DOW CHEMICAL TRIGA  
RESEARCH REACTOR  
LICENSE NO. R-108  
DOCKET NO. 50-264

TECHNICAL RAI RESPONSES (10/12/2011)

Subject: The Dow Chemical Company- License No. R-108; Docket No. 50-264

DTRR Revised response to questions 11, 14, 15-1, 16, 17-1, 17-3, 18, 19, 41, 52, 53, 54, 56 in support of the license renewal.

Figure 4. Upper grid plate

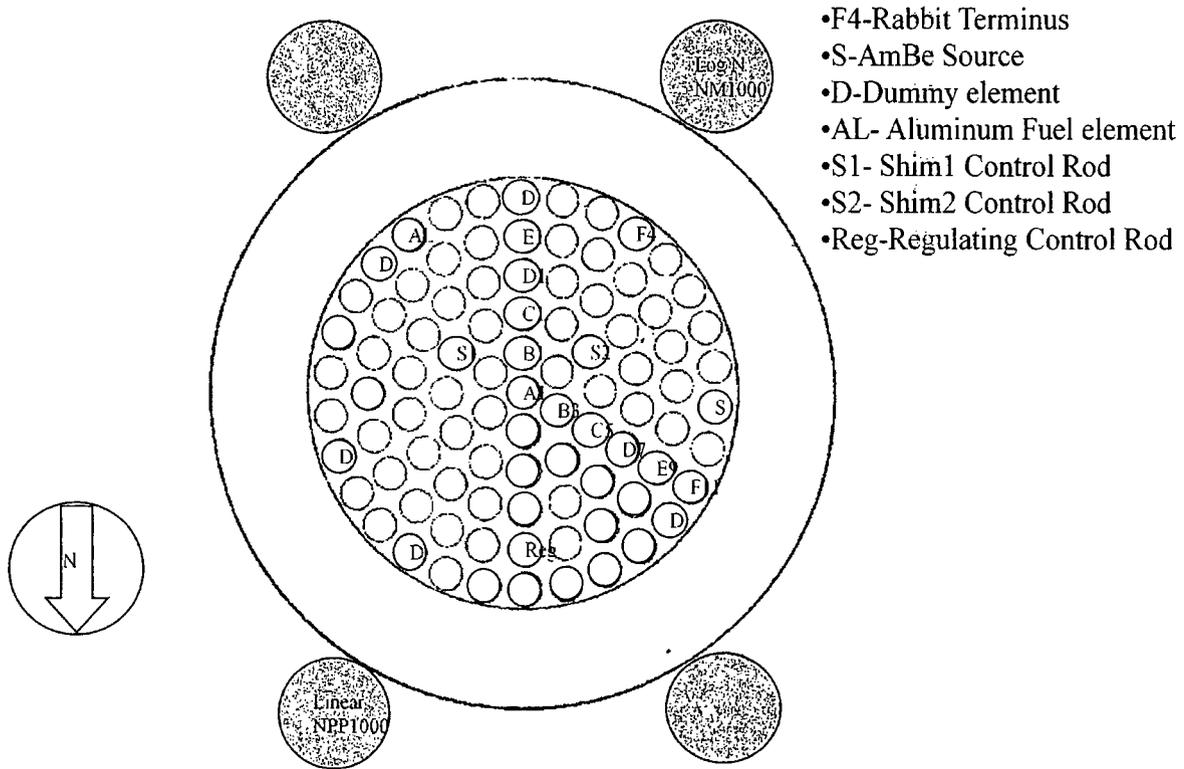
11. NUREG-1537, Part 1, Section 4.2.5, "Core Support Structure" requests the applicant to provide design information pertaining to the core support structure. DTRR SAR, Chapter D, does not provide sufficient information. Please provide figures depicting the upper and lower core plates and provide the dimensions and locations of all penetrations that allow coolant to flow through them.

Two aluminum grid plates fix the position of fuel elements, dummy elements and neutron source. Figure 4 is the schematic drawing of the upper grid plate with the position of the control rods, pneumatic transfer location and source indicated. The upper plate is  $\frac{3}{4}$  inch aluminum and has 1.5 inch diameter holes to position the fuel, dummy elements, control rods, etc. The bottom plate is  $\frac{3}{4}$  inch aluminum and has holes to receive the end pins of the fuel and dummy elements. Thirty-six holes for the natural convection cooling are found on the lower grid plate. The water passes through the upper grid plate by means of the gap between the triflute section of the fuel and the upper grid plate. The penetrations on the lower grid plate are in concentric rings with 7, 12, and 17 holes, respectively. Figure 5 is a photograph of the lower grid plate. This photograph substantiates the as built drawings given by General Atomics, and previous Safety Analysis Reports submitted by The Dow Chemical Company.

In addition to these holes, the fuels are raised above the bottom grid plate by the fuel pin ( $\frac{5}{8}$ " diameter by 2" long). The gap between the fuel and the lower grid plate therefore allows the bottom coolant to flow, in an "open" configuration through the core from the bottom.

Figure 1. Upper grid plate

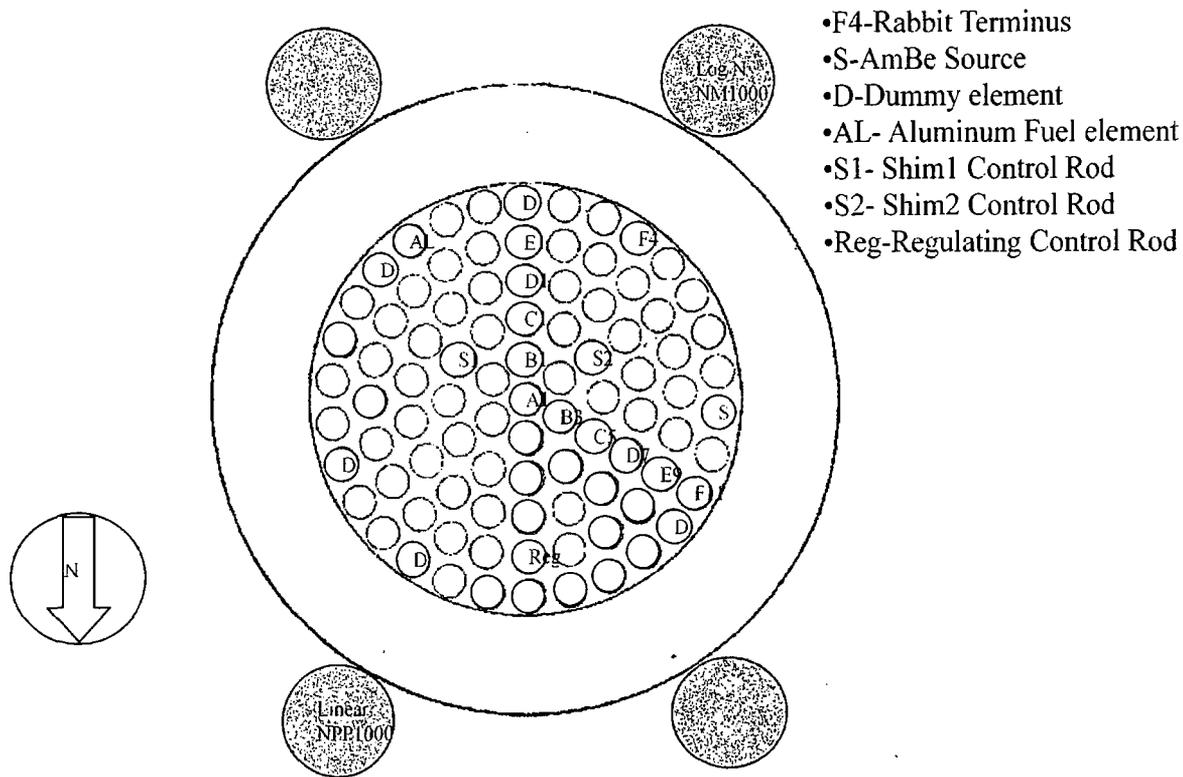
15.2 DTRR SAR, Section A.3, describes the original fuel configuration as having 75 stainless steel (SS)-clad elements and one Aluminum (Al)-clad element. The DTRR SAR does not provide information relating to the DTRR fuel element and control rod layout for the requested power level. Please provide a complete description of the LCC for the requested power level and provide a core diagram showing all components.

15.2 The core configuration is found in Figure 1. The core is loaded with 79 Stainless Steel clad fuel elements, 1 Aluminum clad fuel element and 5 graphite dummies.

Figure 54-1. Diagram of Reactor Room and Adjacent Areas

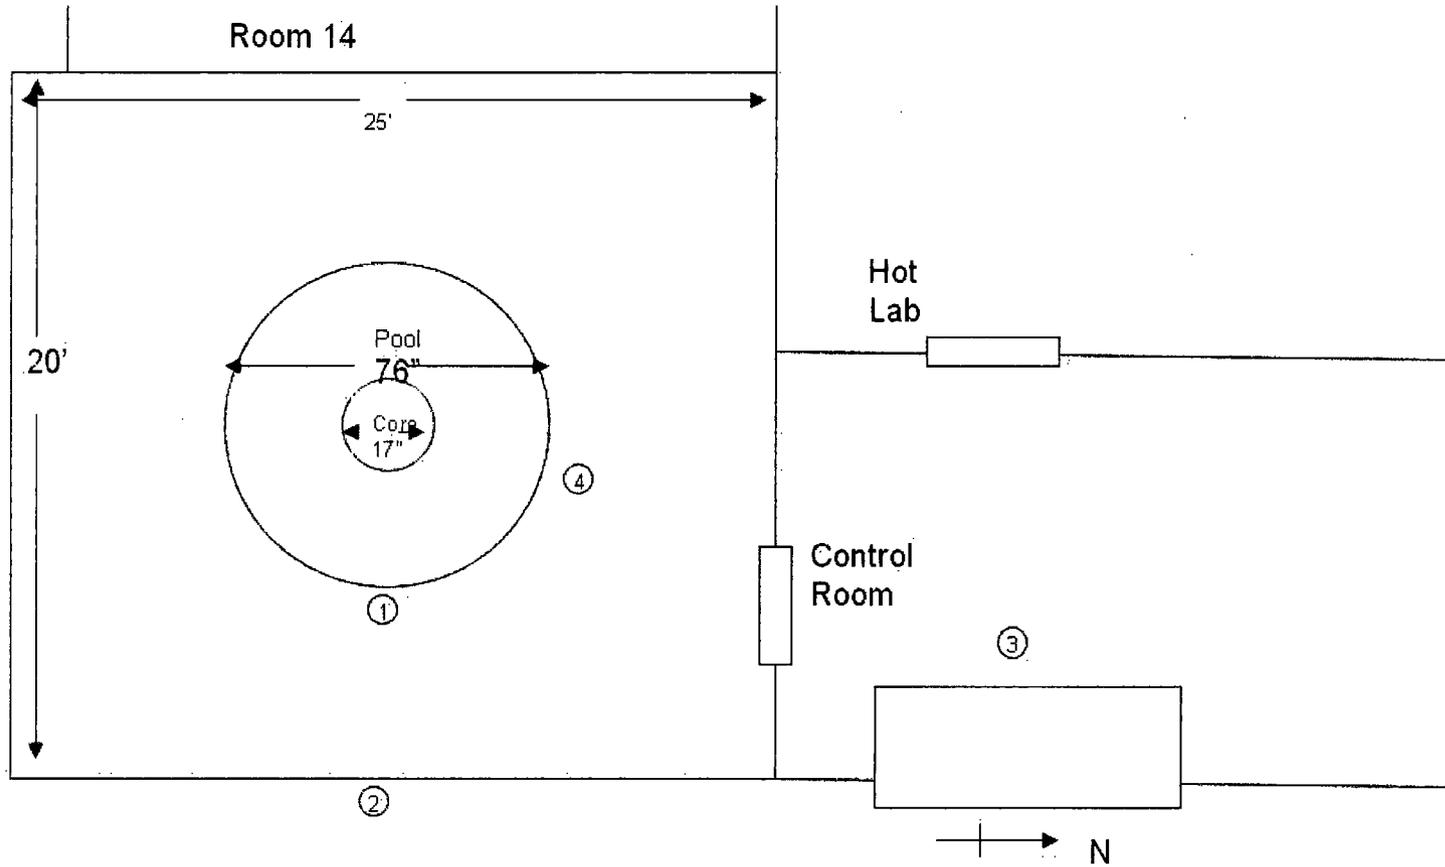
54. NUREG–1537, Part 1, Section 13.1.3, “Loss of Coolant” requests the applicant to provide analysis that assures that doses to the public that could result from a loss of coolant accident do not exceed 10 CFR Part 20 limits. DTRR SAR, Section M.1.1, Table 7 presents exposures resulting from a loss of coolant accident. There is no statement regarding occupational or public dose limits and whether they are met. Please explain this accident analysis in further detail and in terms of meeting the regulatory limits.

Time after complete loss of coolant	Direct radiation – 18 ft directly above core (R/hr)	Indirect Radiation shield top edge of the tank (R/hr) (Position 1 or 4 in Figure 54-1)
10 seconds	3000	0.78
1 day	360	0.090
1 week	130	0.042
1 month	35	0.012

To estimate potential radiation exposure levels from scattered radiation outside of the reactor room (indicated as position 2 in Figure 54-1, which is outside of the reactor building) measured radiation scatter data from dose rates during the operation of the neutron beam tube will be used to estimate potential dose rates generated around the reactor building. Specifically, during an operation of the central beam tube in 1991, measurement survey were made and reported to the Radiation Safety Committee, The Dow Chemical Company. This report documented measured gamma and neutron doses during the operation of a neutron beam tube that consisted of a 1.5" streaming pathway that allowed collimated neutrons to travel through a helium filled aluminum pipe without being shielded. Figure 54-1 shows the layout of the reactor pool and the areas surrounding the reactor room.

To estimate potential radiation exposure levels from scattered radiation inside the reactor control room (position 3 in Figure 54-1), a similar method will be used to predict scattered radiation dose rates. The dose rate measured during the beam tube experiment in the control room reactor console was 0.55 mrem/hr and the dose rate on the north side of the reactor as 8.5 mrem/hr (marked as location #4 in Figure 54-1). Scaling the dose rates using the factor 91 (i.e. 780/8.5), as before, a control room dose rate of 50 mrem/hr from scattered radiation is the calculated expected dose rate immediately following such an incident.

It is important to note that location 3 shown in figure 54-1 and whose dose rate is addressed above, is the only occupied location just outside of the reactor room.
